**TO:** Chairwoman Laura Semanson, Forsyth County  
**ATTN TO:** Leslie Silas, Planning Manager, Forsyth County  
**FROM:** Mike Alexander, Director, ARC Center for Livable Communities  
**RE:** Development of Regional Impact (DRI) Review

**Name of Proposal:** Empire Highway 306 DRI 3594

**Description:** A DRI review of a proposal to construct a mixed-use project with 60 single family lots, 69 townhomes, 303 multi-family apartments, 13,000 SF of office space, 10,000 SF of retail, and 20,000 SF of restaurant space on a 68 acre site in Forsyth County. The site has been partially developed for agricultural use. Baldrige Creek runs through the site.

0000078213  
ECF  
CRG  
BWS  
01/18/2022  
018754023  
DRI SITE PLAN  
C1-95

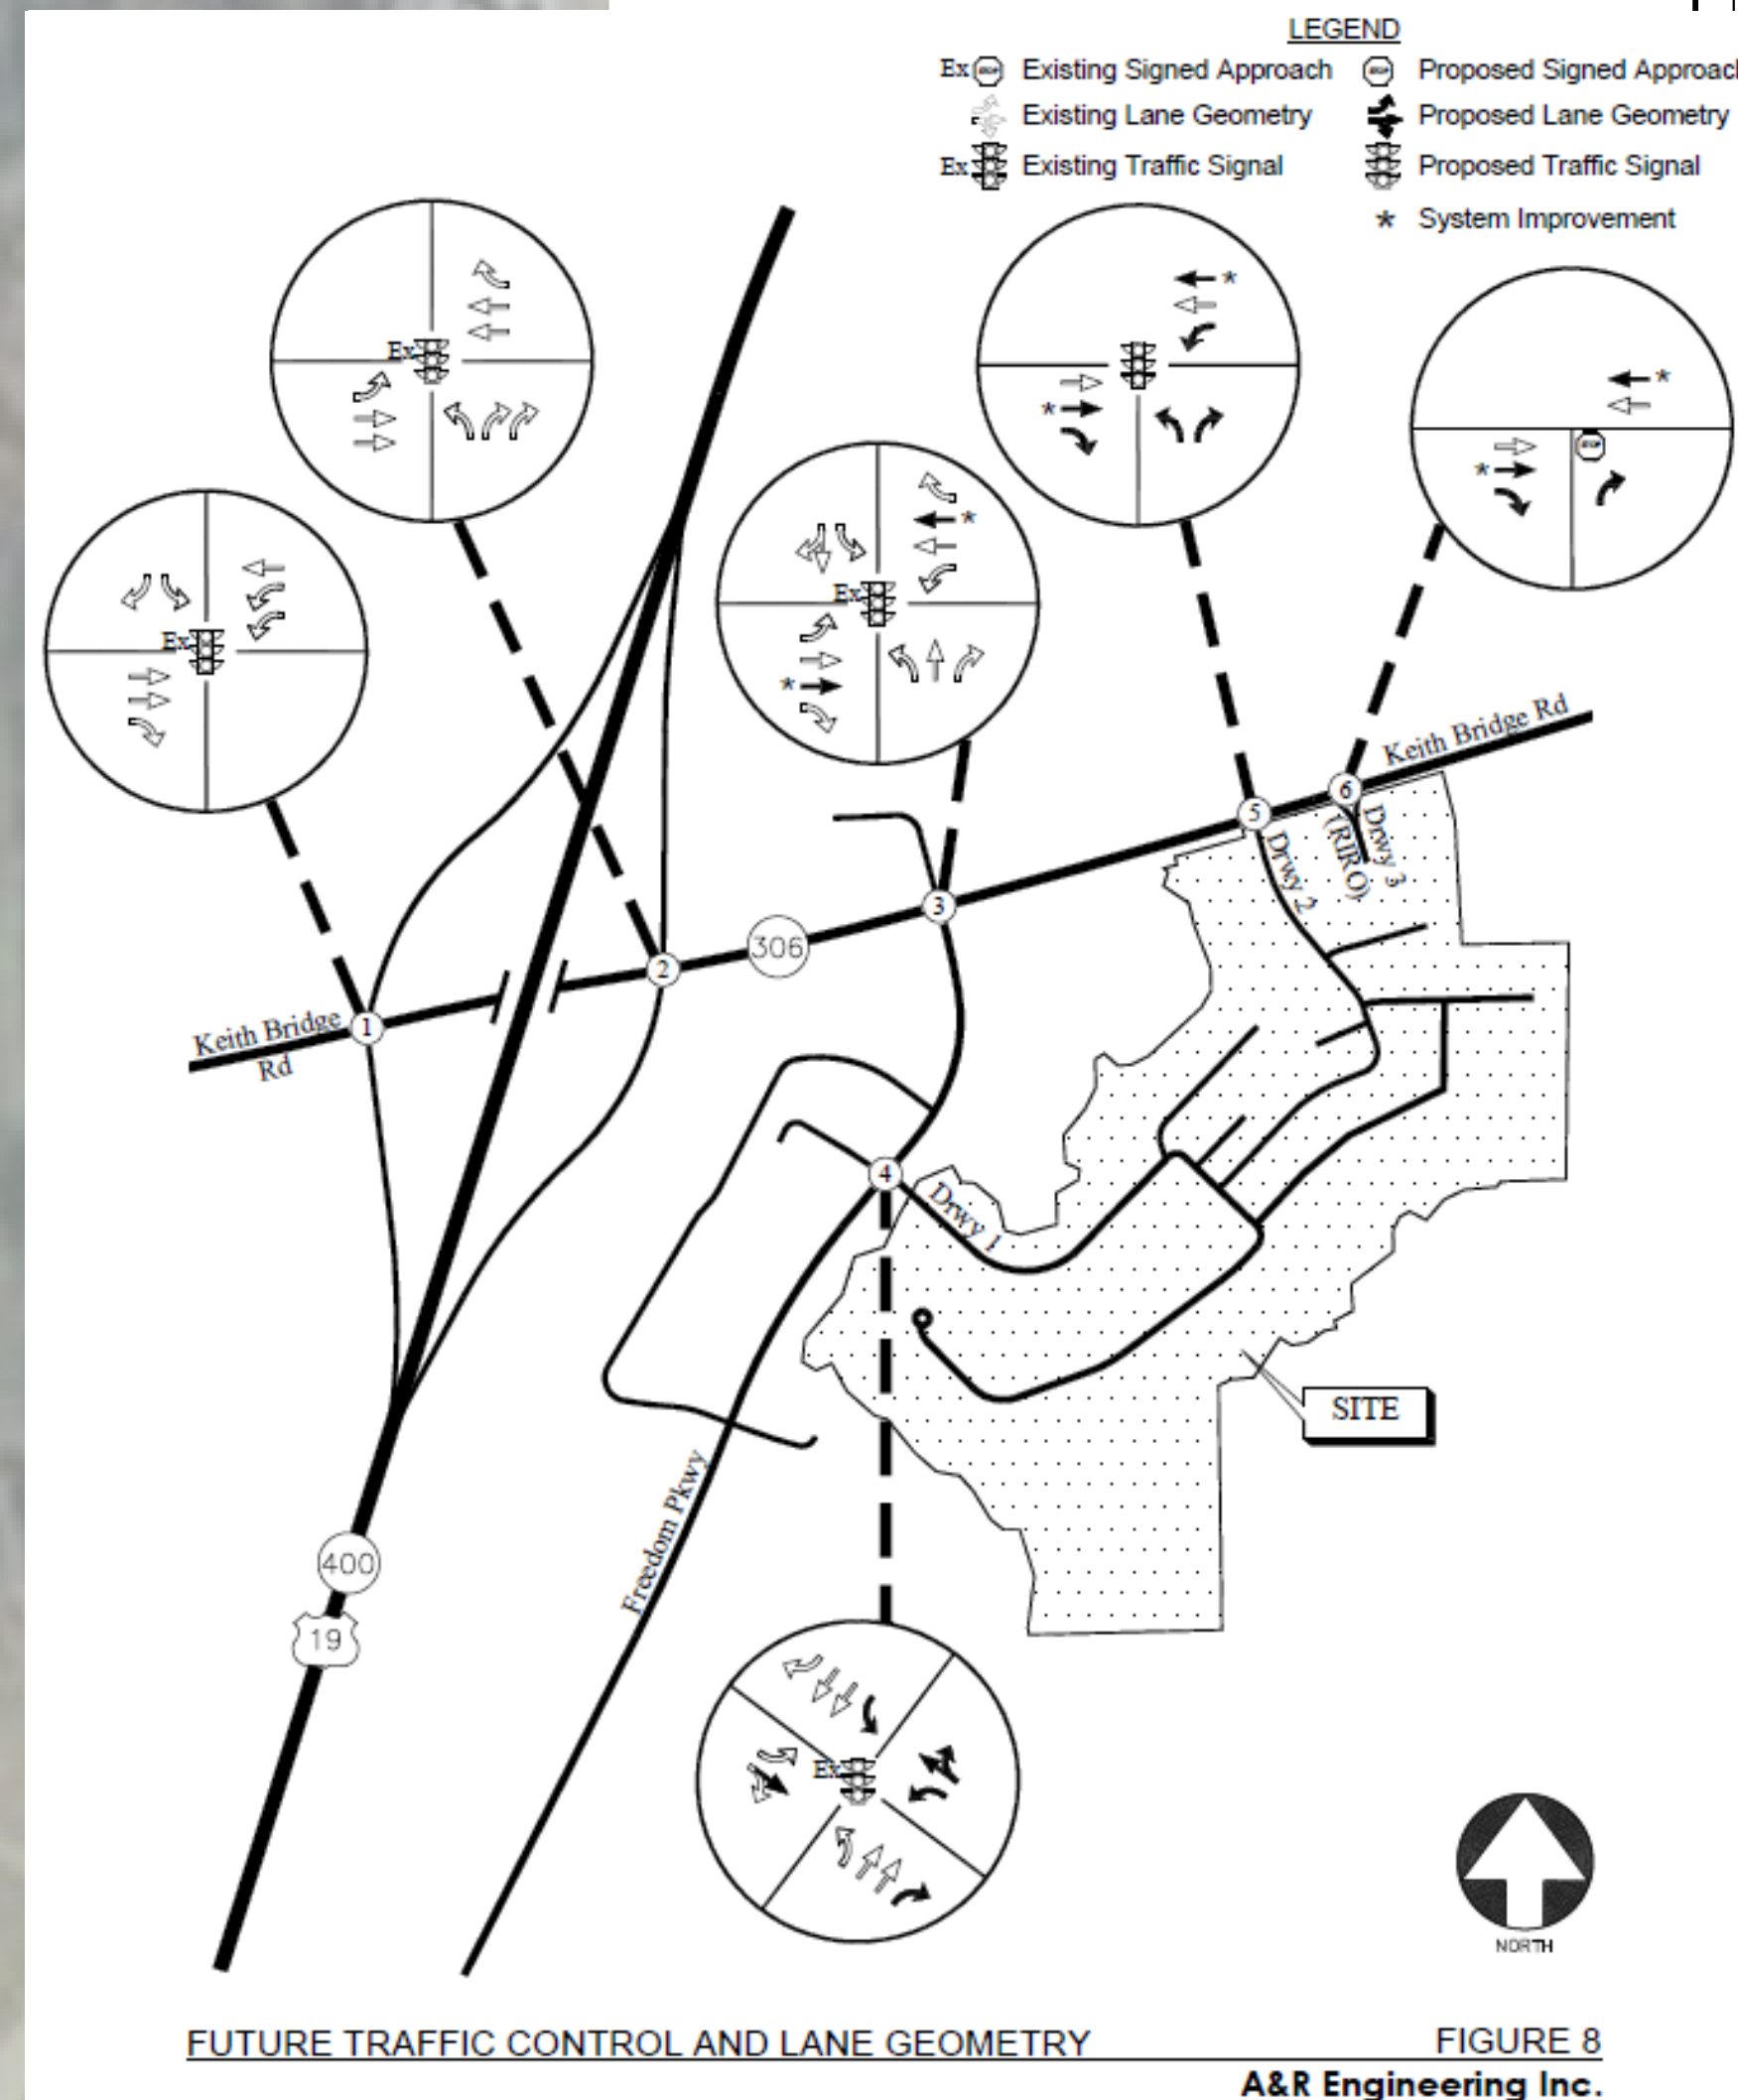
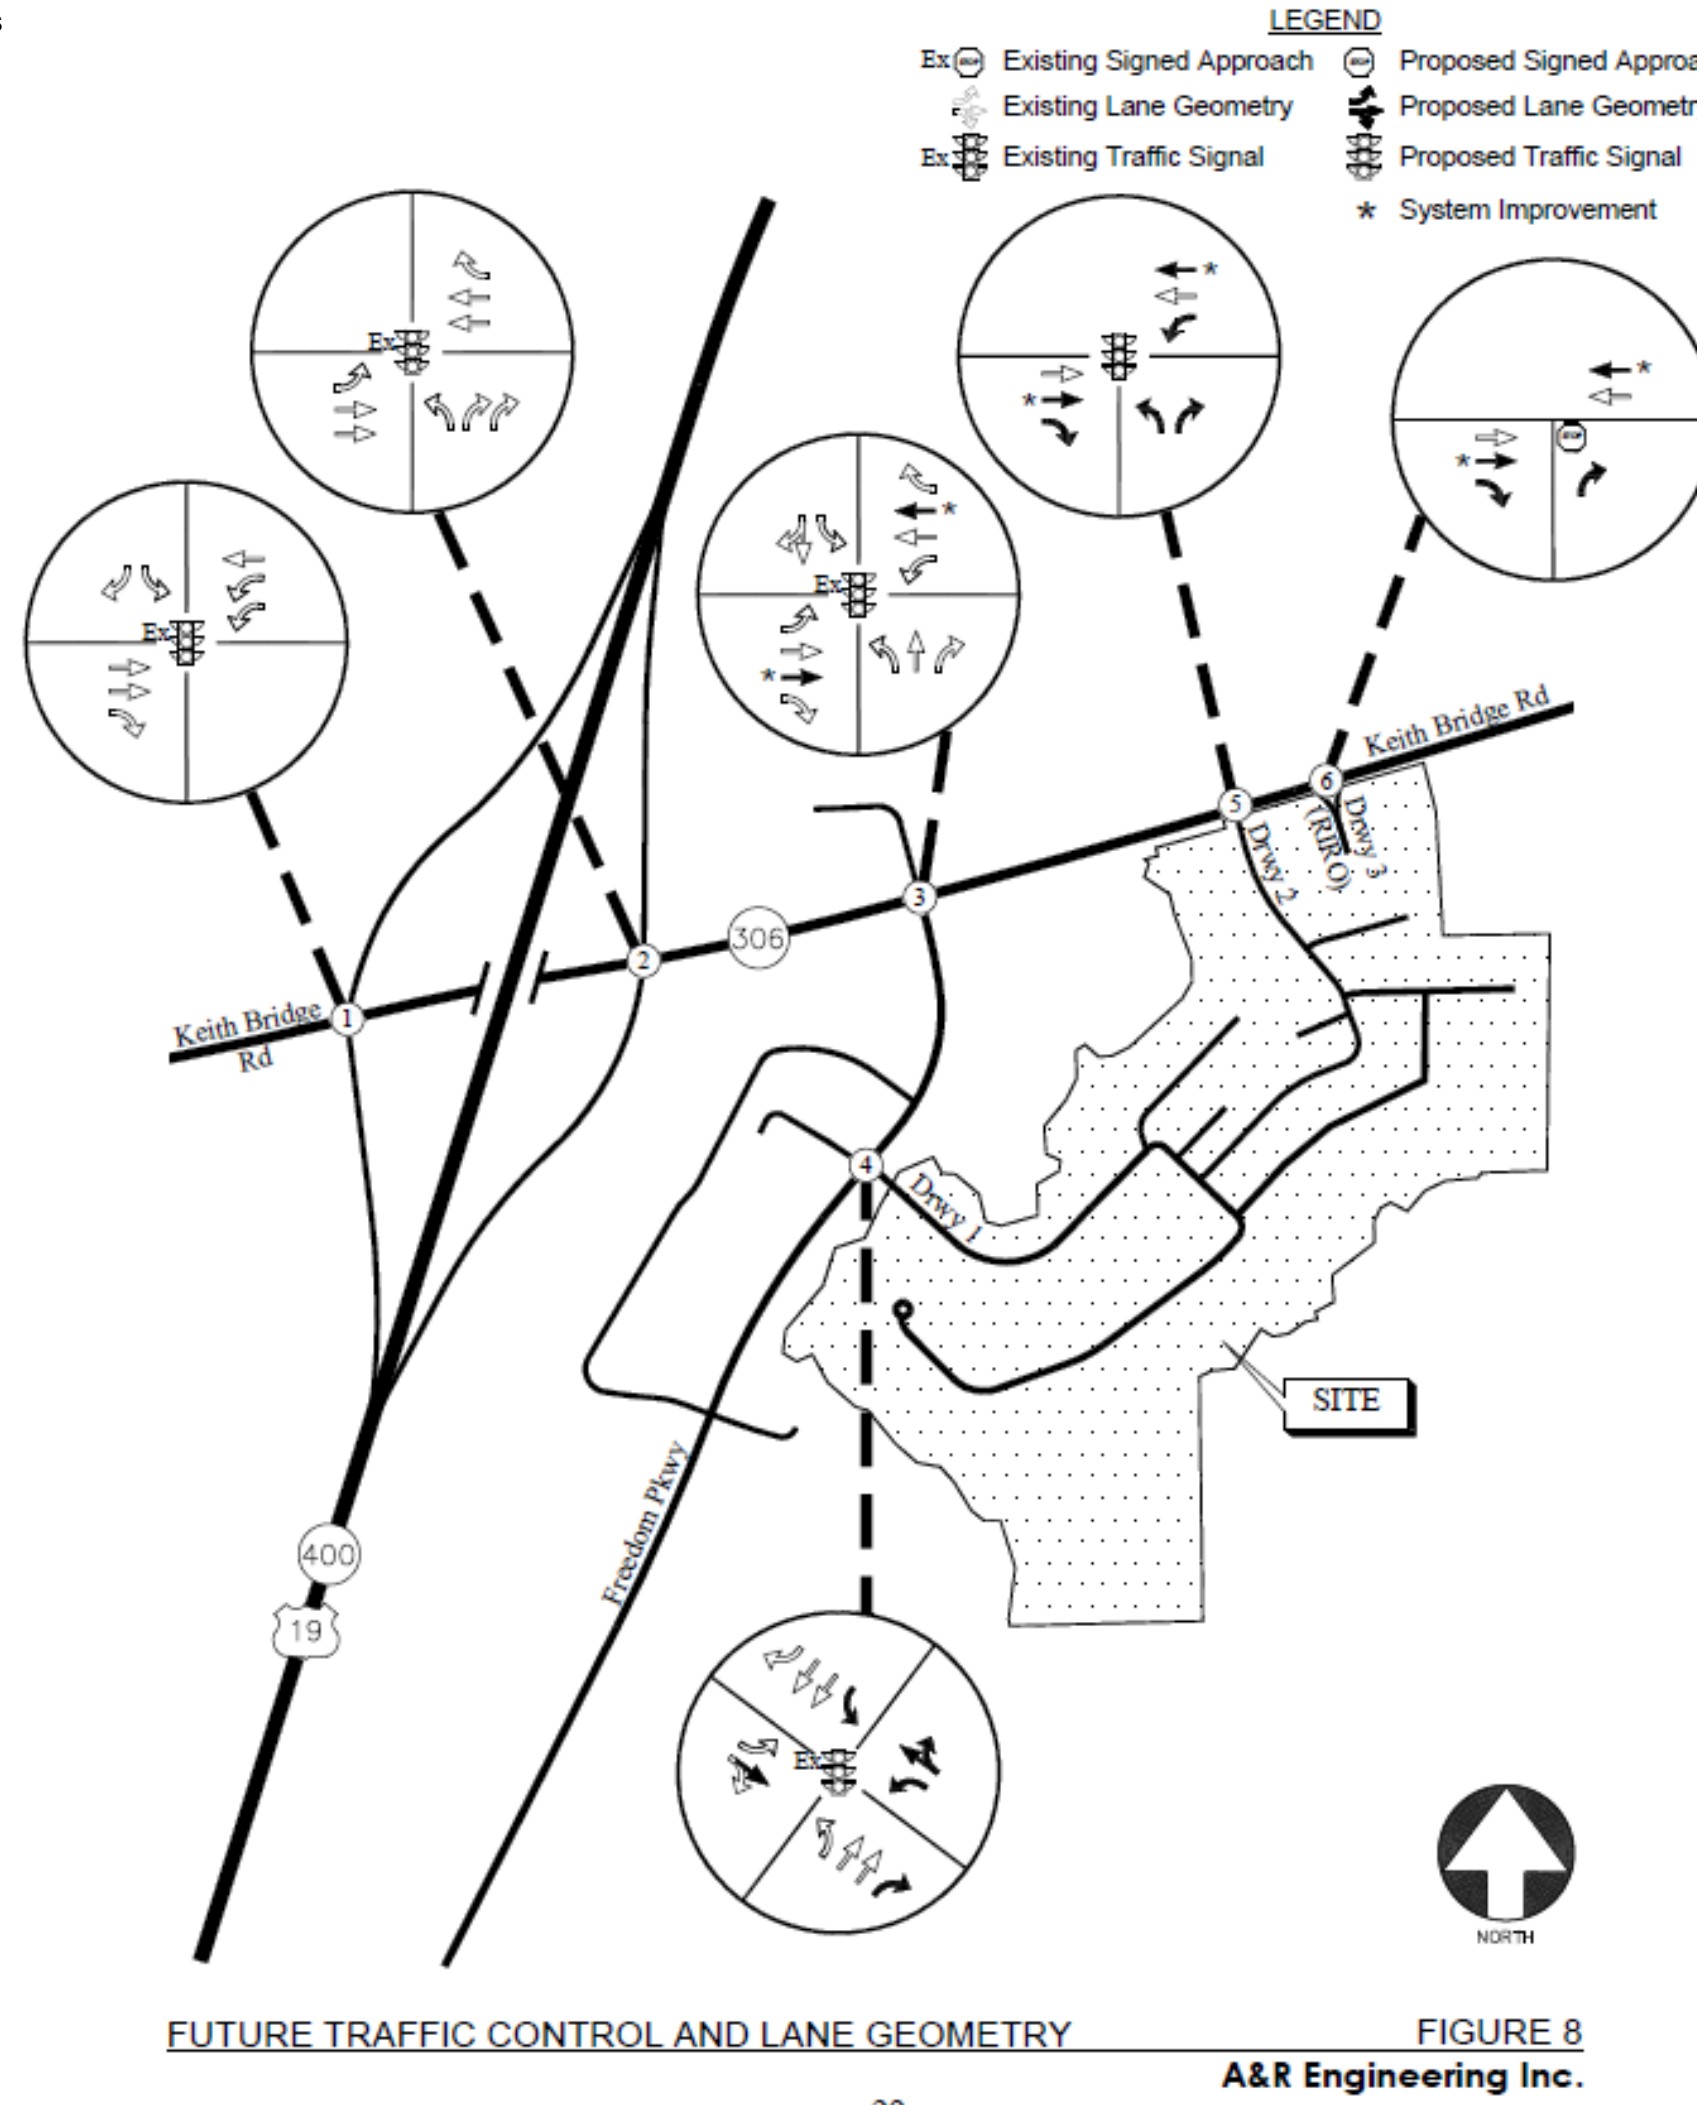
A total of 1,126 parking spaces are provided which is almost double the required number of 677 spaces; no EV charging stations appear to be proposed. A reduction of total spaces to an amount closer to the minimum required and the provision of EV parking spaces would be supportive of regional transportation policies.

Both the USGS coverage for the project area and the submitted site plan show two streams on the project property. Baldrige Creek runs along the northwestern, western and southwestern sides of the property and a tributary to Baldrige runs along the eastern side of the project property, joining Baldrige Creek near the southern end of the property. The site plan shows the 25-foot State Sediment and Erosion Control buffer as well as the Forsyth County's Stream Buffer Ordinance's 50-foot stream buffer and 75-foot impervious setback along both streams. The only proposed intrusions on the site plans are a stream crossing accessing

the property from Freedom Parkway, which is exempt from the buffer standards and the possible intrusion of a proposed 10-foot wide multi-use trail along Driveway 1 a few feet into the 75-foot setback, which may require a variance from the County.

Much of the existing site is wooded; additional retention of existing trees on the site would be desirable and in keeping with regional goals regarding carbon sequestration and climate change/heat island effect mitigation.

Incorporation of green stormwater and heat island mitigation designs for the roughly 1,126 surface car parking spaces proposed would be supportive of regional environmental policies.

Approximately 36 acres of the site are shown as open space and water quality protection buffer areas. Designation of this area as managed open/conservation space would substantially reduce the overall impact of the project. There may be potential opportunities for linking these fragmented undeveloped areas with adjacent undeveloped or protected areas to ensure their maintenance and potential use for recreation or habitat preservation.
